**THE TIMBERYARDS BY RTL CO - MOD 1
VICTORIA ROAD, SYDENHAM ROAD, FARR STREET, AND MITCHELL STREET, MARRICKVILLE**

**RESPONSE TO SUBMISSIONS - THE TIMBERYARDS BY RTL CO.
VICTORIA ROAD, SYDENHAM ROAD, FARR STREET, AND MITCHELL STREET, MARRICKVILLE**

TAB A – TfNSW comments

Figure 1: Swept Path Excerpt for 12.5m HRV

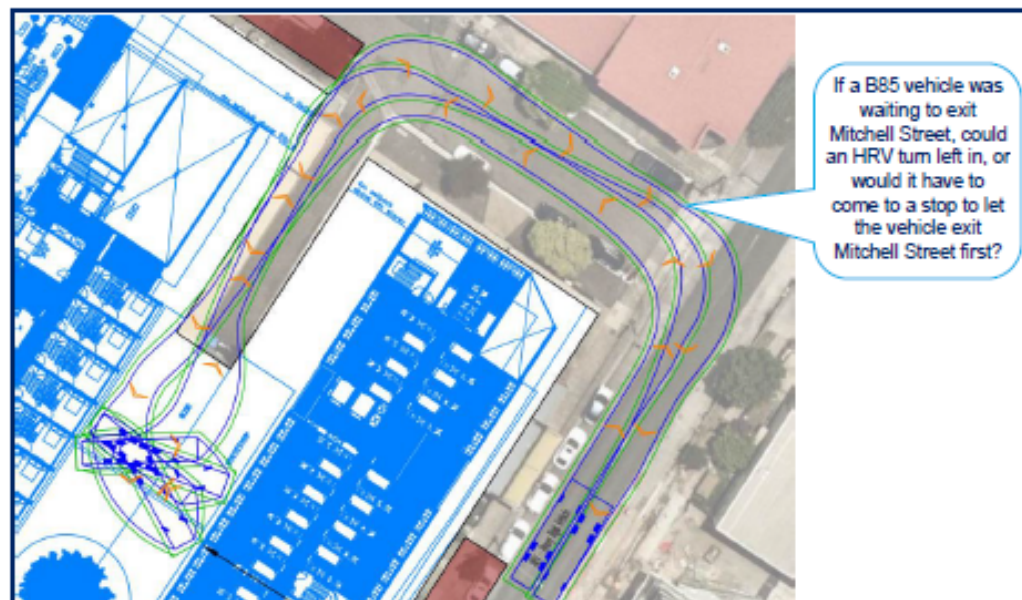
- a) A 12.5m long Heavy Rigid Vehicle (HRV) appears to require the use of the majority of the width of Mitchell Street to access the site, such that another vehicle would not be able to wait to turn out of Mitchell Street while the HRV turns left into Mitchell Street. In consultation with Council, DPHI may wish to consider whether there is a need to include a condition of consent requiring the installation of 'No Stopping' signage for an appropriate length on Mitchell Street, adjacent to the intersection with Victoria Road, to provide space for access by HRVs.
